Project No. CA-GLD-1791470A

RESPONSES TO STOVEL AND ASSOCIATES INC. REVIEW COMMENTS – PROPOSED CBM ABERFOYLE SOUTH LAKE PIT

The table below provides WSP's responses to review comments made by Stovel and Associates Inc. (Stovel) (Harden) on April 19, 2024 and received by MHBC Planning from the Township of Puslinch on April 29, 2024 related to the ARA licence application for the proposed CBM Aberfoyle South Lake Pit.

**Figure 1 – Base of Resource
Elevation**

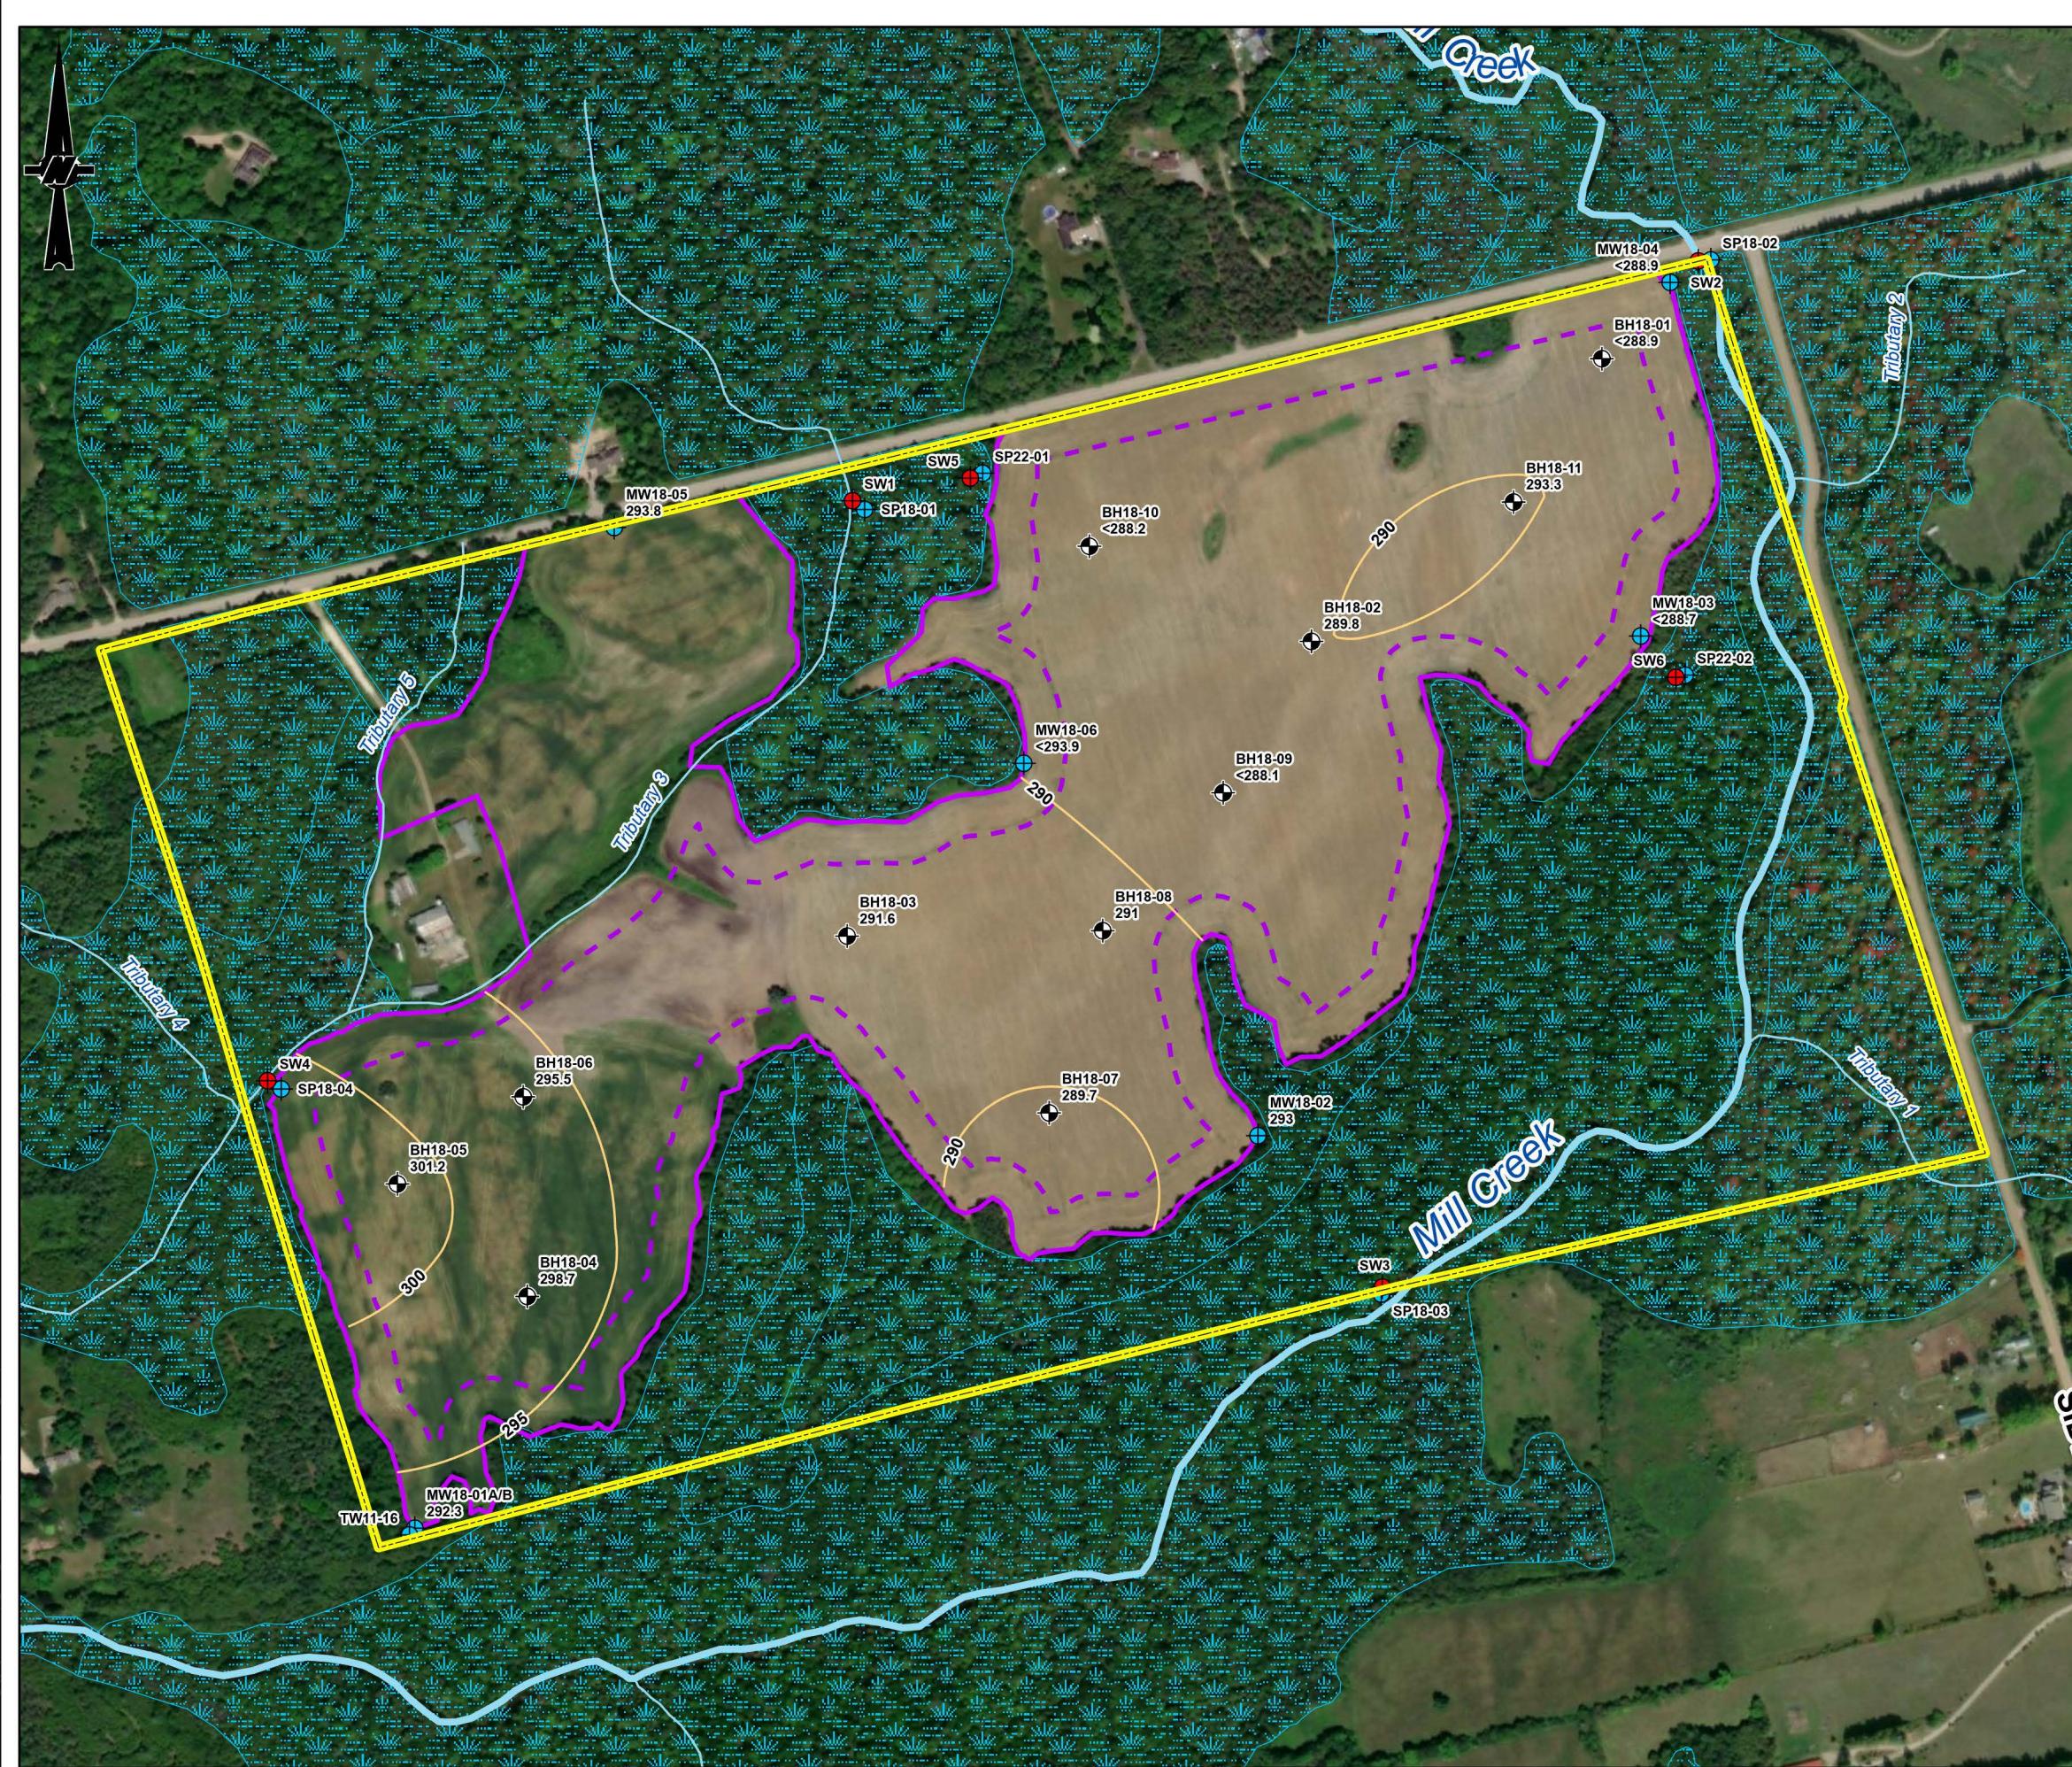
Num	Topic	Section	Stovel Comment	WSP Response
7	Agg Resource Rpt / Site Plan	General	<p>An estimated volume of the mineral aggregate resource was provided by the applicant's consultant and summarized in the Planning Report. The volume calculations should be reviewed based on the proposed extraction plan, given that the depth of the proposed pit is to the elevation of 285 masl. This represents a 20 m depth of extraction; however, an extraction depth of 12.5 m was reported in the WSP Aggregate Resource Evaluation. It is recommended that the proposed pit floor depths be adjusted to an elevation that has been substantiated by borehole results and suggested by WSP.</p>	<p>See response to comment #4.</p> <p>Note that the Aggregate Resource Report does not recommend a 12.5 m extraction depth. Section 6 notes that an average thickness of the resource is 12.5 m, below a surficial layer up to 3 m thick, and that the estimate is limited by the depth of boreholes where the bottom of the resource was not encountered.</p>
